Addendum No. 1
Big Dipper Ranch – Pasture 1 – Fence Installation

To: Request for Bid Recipients
From: Elaina Cuzick, Project Manager
Date: October 13, 2016
Re: Addendum 1

Big Dipper Ranch - Pasture 1 - Fence Installation - Amended

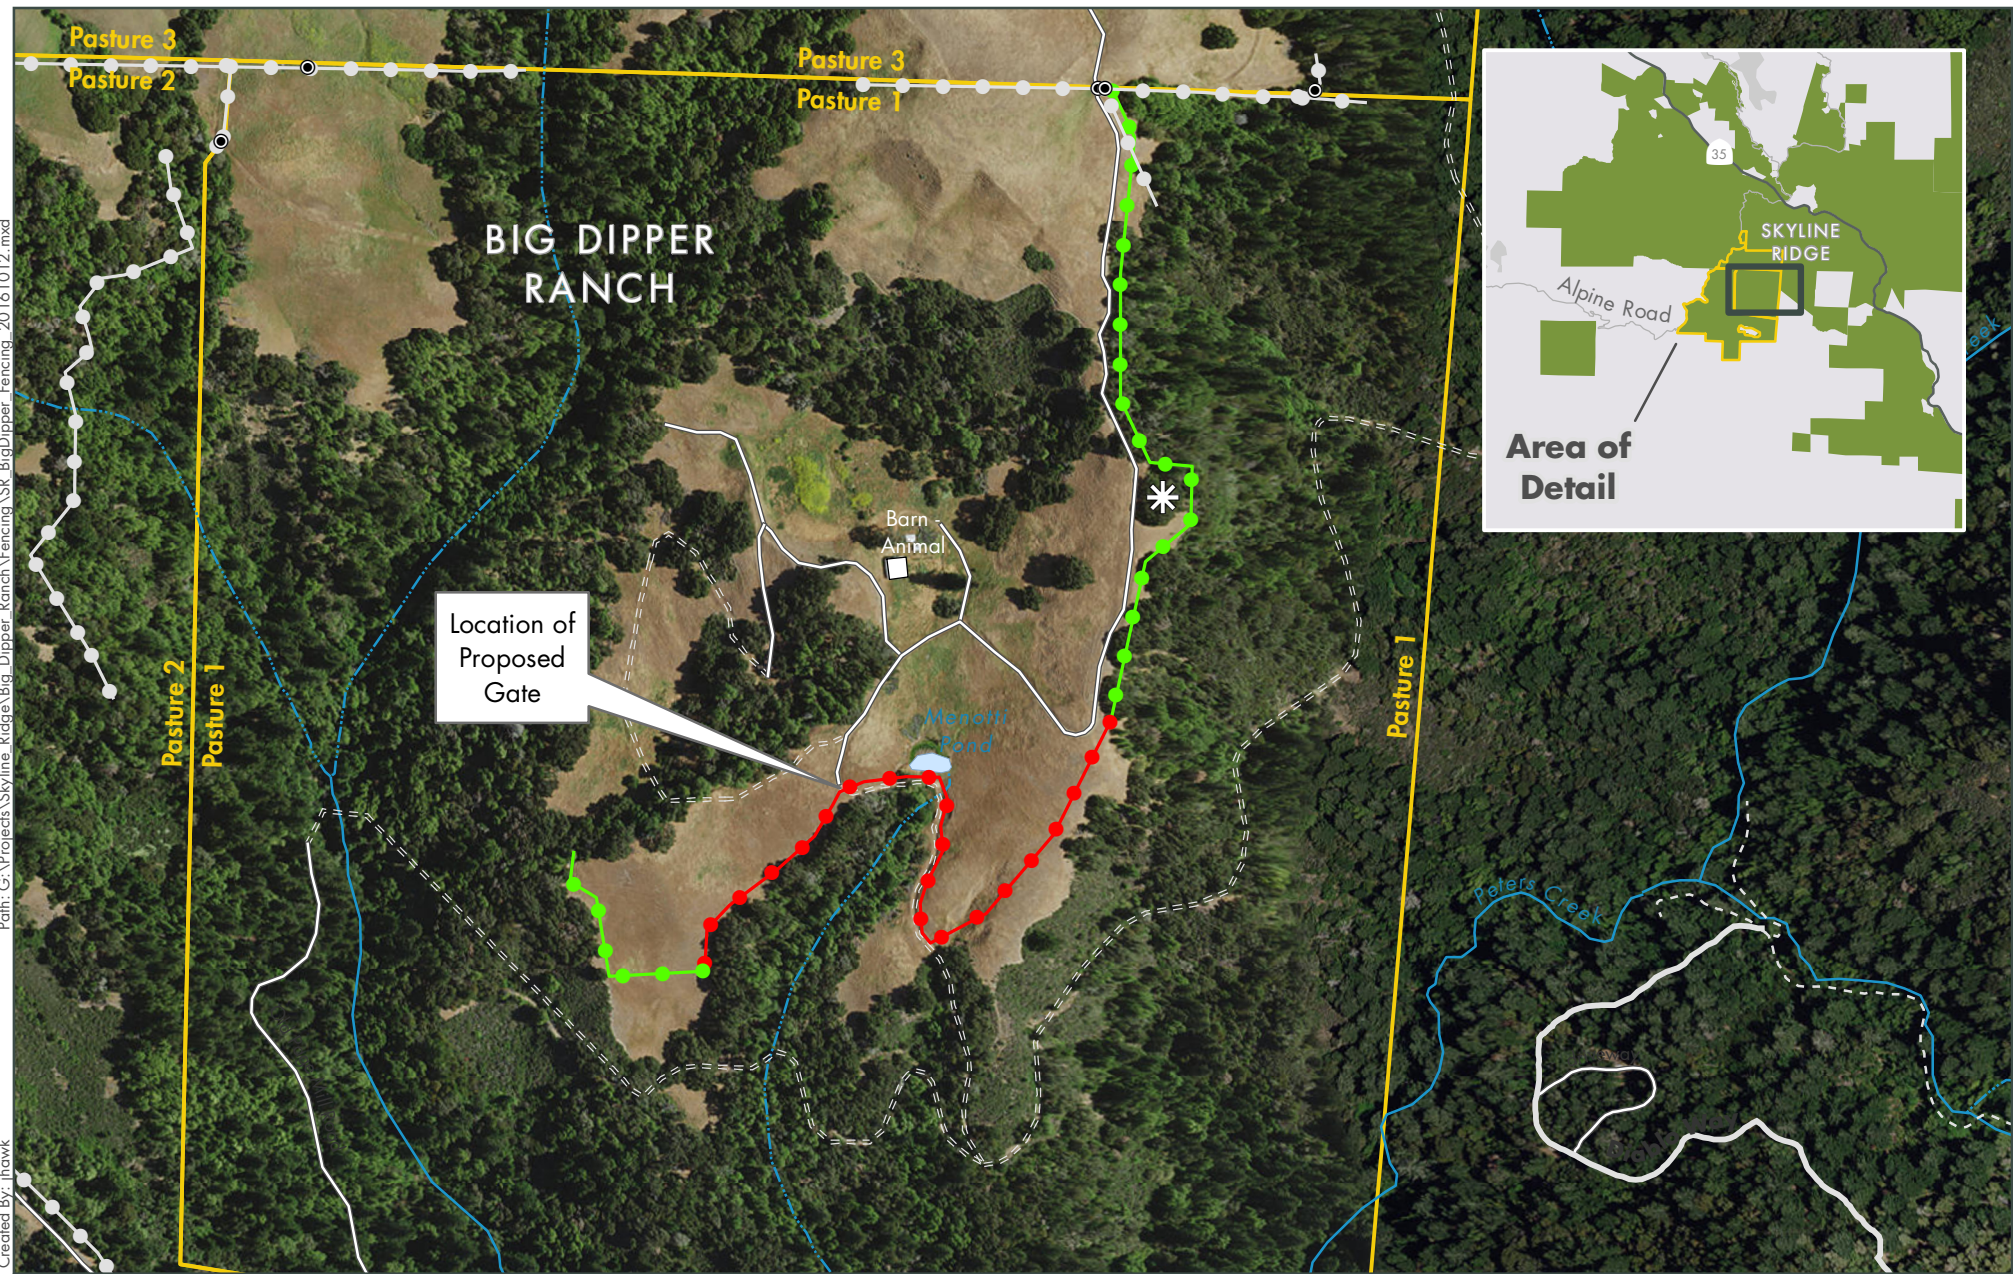
4. Project Map has been amended to show new route for Pasture 1 fence.
5. Bid Questions and Answers

12. Question:
Does the fence have to go around the large rock formation south of the ranch road?

14. **Question:**
Do you think closer to the road would be a better route than down in the wooded slope area?

Response:
Yes, please see the amended Project Map with the Addendum.

Response:
Yes, a revised Project Map will indicate the new path of the fence line. The linear feet of the project will be adjusted to match the new route of the fence.
